NOTICE OF REGULAR MEETING OF THE PLANNING AND ZONING COMMISSION HICKORY CREEK TOWN HALL 1075 RONALD REAGAN AVENUE, HICKORY CREEK, TEXAS 75065 TUESDAY, MARCH 18, 2025, 6:00 PM

Project Name: Hickory Heights Phase 1-A

FINAL PLAT LOT 1, BLOCK A OF HICKORY HEIGHTS PHASE 1-A 1.934 ACRES IN THE M.E.P. & P.R.R. CO. SURVEYA- 915 ETJ TOWN OF HICKORY CREEK DENTON COUNTY, TEXAS

Final Plat 1st Review

Notes:

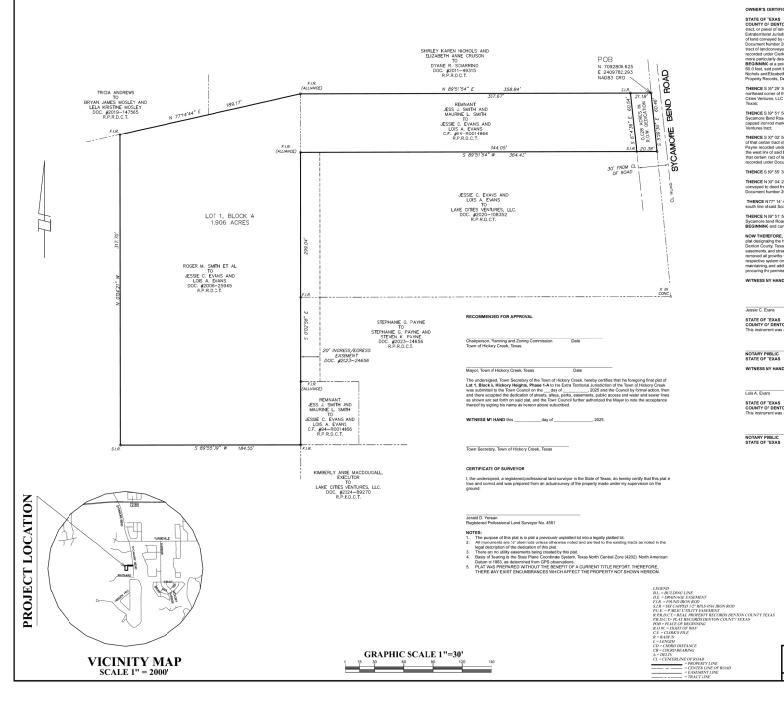
- Fire: Reviewed; No Comment
- Engineering: Reviewed; No Comment
- Planning/Zoning: 16 ft utility easement missing, 30 ft set back line missing, Add Standard Notes
- Environmental Health: Reviewed; No Comment
